# UNITED STATES PATENT AND TRADEMARK OFFICE

APPLICATION NO.	FILING DATE	FIRST NAMED INVENTOR	ATTORNEY DOCKET NO.	CONFIRMATION NO.
10/531,363	04/14/2005	Stig-Erik Hultholm	4819-4738	6979
27123 7590 07/07/2008 MORGAN & FINNEGAN, L.L.P. 3 WORLD FINANCIAL CENTER NEW YORK, NY 10281-2101				
EXAMINER				
MC GUTHRY BANKS, TIMA MICHELE				
ART UNIT		PAPER NUMBER		
1793				
NOTIFICATION DATE		DELIVERY MODE		
07/07/2008		ELECTRONIC

### Office Action Summary

## **DETAILED ACTION**

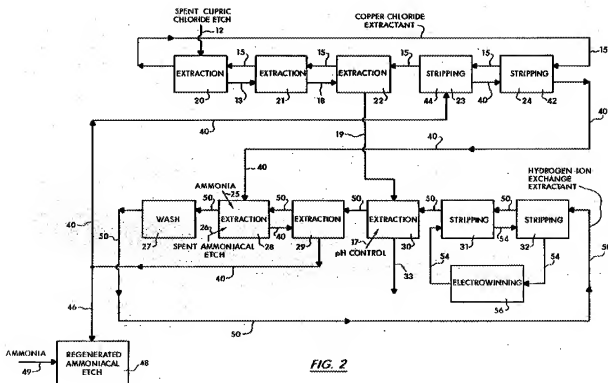
Regarding the further steps in Claim 1, Jensen teaches selectively extracting and recovering copper from acidic solutions such as those obtained by leaching copper ore (column 3, lines 62 and 63) as shown by FIG. 2:

Regarding the claimed two-stage liquid-liquid extraction, that Jensen teaches having more extraction stages does not negate Jensen's applicability as prior art. The transitional term “comprising,” which is synonymous with “including,” “containing,” or “characterized by,” is

inclusive or open-ended and does not exclude additional, unrecited elements or method steps. See MPEP § 2111.03. Regarding the other valuable metals, it would be expected that the other metals would remain in solution since the copper is selectively extracted, e.g. unwanted metallic ions (column 11, lines 13 and 14). The partitioning step is met by extraction step 22 with stream 19 going to the pH control and stream 15 going to stream 40. It would be obvious to recycle the copper feed from which copper chloride is selectively extracted as an acidic leach solution to reduce operating costs (column 5, lines 60-65). Ammonia or other neutralization agents are added at 17 (column 8, lines 40-54). The second extraction stage is met by 29 and 30. The first and second organic solutions are sent to stripping stage 31 and 32 via 50, from which copper is electrowon.

The extraction is liquid-liquid. The stripping solution is sulfuric acid (column 5, lines 33 and 34). Regarding Claim 7, FIG. 2 shows parallel flow. Regarding Claim 8, the extraction unit operates at 35 °C (column 16, line 34). Regarding Claim 9, line 54 (sulfuric acid) in FIG. 2 comes from electrowinning stage 56 to stripping stage 31 (column 11, lines 20-32). It would have been obvious to one of ordinary skill in the art at the time the invention was made to use the copper recovery process of Jensen with the process of DeMarthe et al, since Jensen teaches that liquid-liquid extraction of copper is well known (column 2, lines 30-33); furthermore, the disclosed process economically and effectively utilizes extractants and provides a diversified copper product (column 18, lines 35-40).

FIG.1.

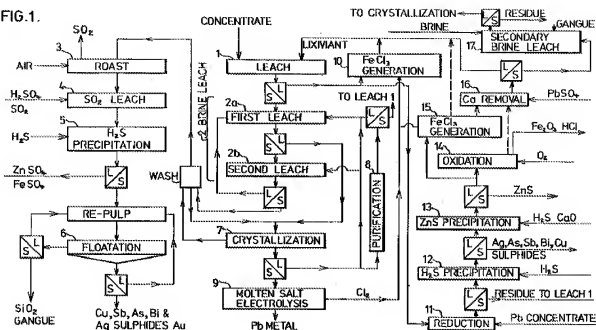
DeMarthe et al in view of Jensen and Preidel discloses the invention substantially as claimed. However, DeMarthe et al in view of Jensen and Preidel does not disclose the precipitation step as claimed. Milner et al teaches treating complex sulfide concentrates. The

solid leach residue containing iron, precious metals and sulfur is shown in Figure 1 (see also column 6, lines 21 and 22).

The combination of DeMarthe et al in view of Jensen and Preidel and Milner et al would have yielded the predictable result of recovering desired metals present in the sulfide concentrates.
